PC 23-15

Variations for an expansion of the existing banquet hall

Shahi Banquets is proposing a building expansion with three separate additions and increasing the overall height of the building:

Figure 1 AREA OF ZONING RELIEF

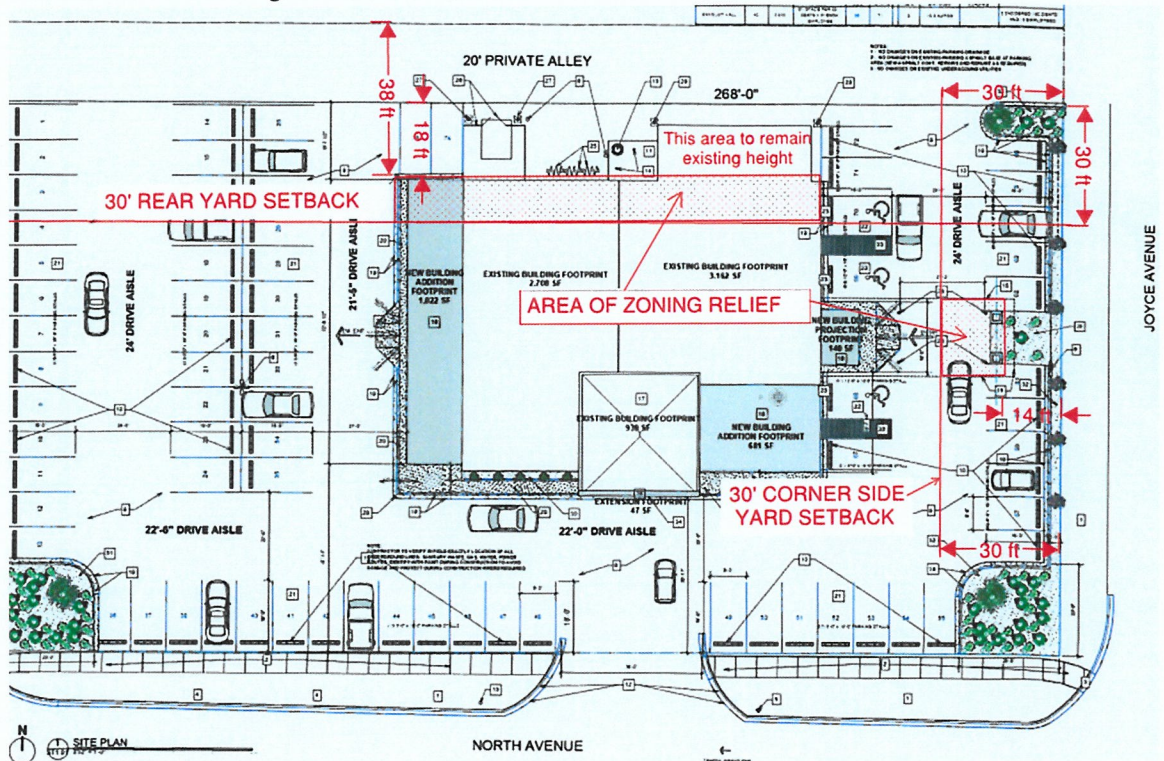
1. Pursuant to Section 155.416(F)(2) approve a variation for a corner side yard setback of 14’ where 30’ is required. The petitioner proposes to construct a porte-cochere entrance (permanent canopy structure) over the east drive aisle for guests to exit vehicles covered from the weather. See Figure 1 below.

Staff supports this request since the proposed removal of two parking spaces required for the supports of the structure does not fall below the required per the zoning code of 72 parking spaces and provides the opportunity for additional landscaping island for the parking lot. Furthermore, the proposed porte-cochere would be seen from Joyce Avenue to the east and a residence to the north located at 2N048 Joyce Avenue that is approximately 70’ from the proposed porte-cochere entrance. This house is approximately 43’ from an existing addition to the existing building constructed in 1974 (permit #22858 for a storeroom, no plans were found with the permit). This existing addition is approximately 5’ from the subject’s rear property line and 25’ from the 2N048 Joyce Avenue property line.

The petitioner proposes to construct an addition on the west side of the existing building for additional storage and an office. No further additional banquet seating is proposed in this addition. See Figure 1. This addition and increasing the height of the building overall requires the variance.

Figure 2 - SITE PLAN FROM PERMIT 20500 (from 1972)

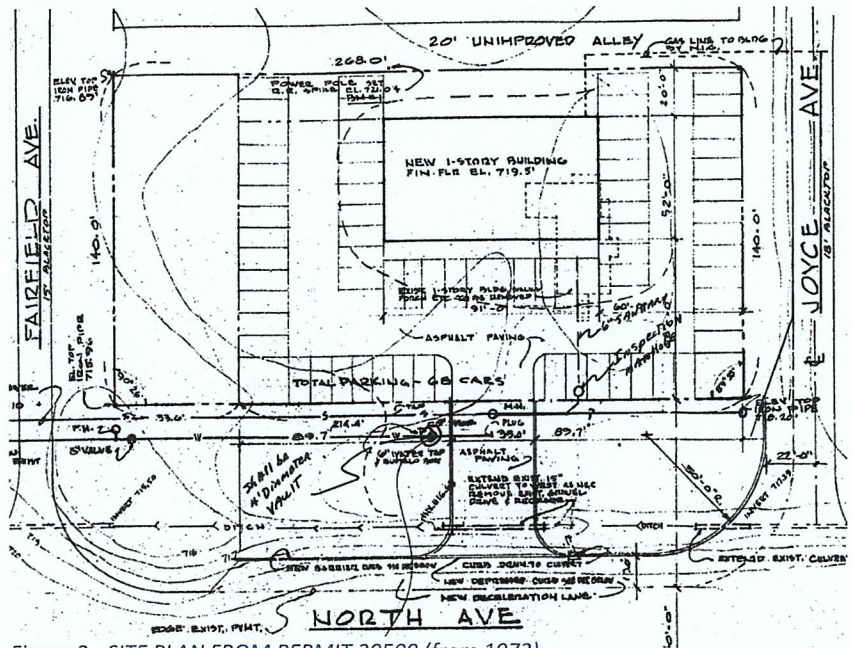
Staff supports the request noting that it appears that the property was intentionally developed with the existing alley providing direct access to the parking lot as evidenced by the approved plans for permit #20500 (see Figure 2). The proposed addition will require the removal of seven of the 82 existing parking spaces but will not fall below the required per the zoning code of 72 parking spaces. The variance request would not alter the neighborhood character since whether the alley is privately owned or not, does not change its appearance.
